SUBJECT: LA 6-200-C Model

DATE: December 30, 1935

TO ALL OFFICES:

FIG. 2

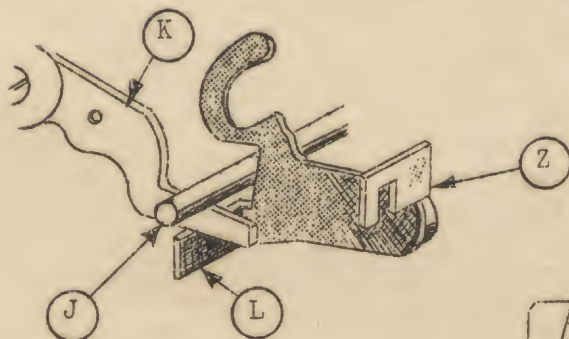
- 1 Stock has been removed from the 49070 counting finger (A) to avoid interference with the movement of the 47900 plunger rod. Figure 1.
- 2 If, after the trip lever (K) and the 41-776 guide bracket (Z) have been adjusted the plunger rod (J) should strike the inner side of the 41-777xl trip lever (K) instead of positioning over it as shown in Figure 3, remove stock from the top of lug (L) to suit.

FIG. 3

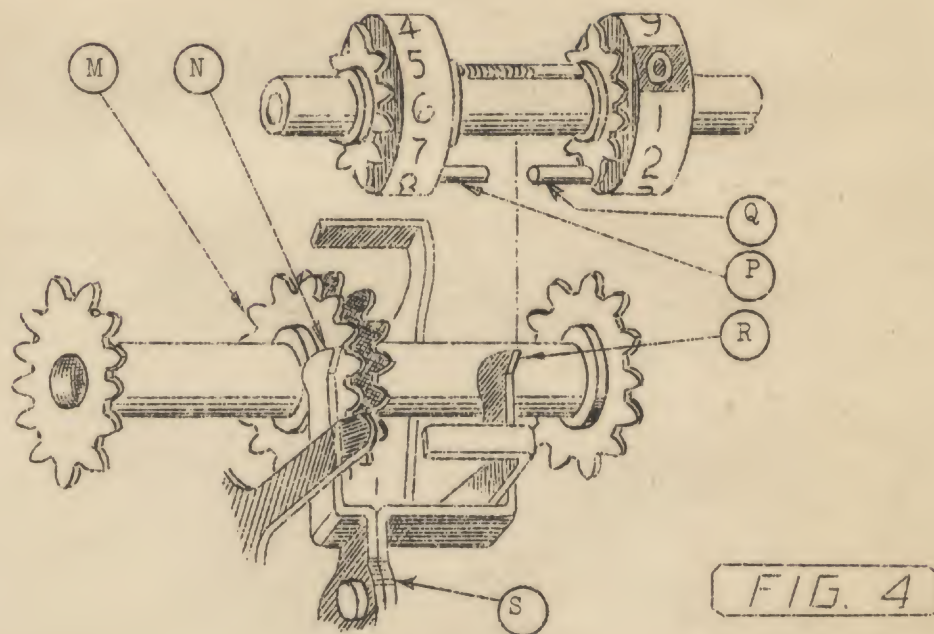
- 3 If the plunger rod (J) does not withdraw from engagement with the trip lever (K) when the multiplication lever is positioned toward the rear of the machine, bend the offset (C) of the plunger rod inward at (X).

- 4 If the plunger rod (J) does not engage the trip lever (K) when the multiplication lever is in neutral, bend the offset (C) of the plunger (J) outward at (X).

6. The outer prong (N) of the trip lever (S) should be adjusted as close as possible to the extra carry gear (M) without causing it to bind.
7. Care should be taken that the clearing pins (P) and the 41-527 carrying pins (Q) do not interfere with lug (R).
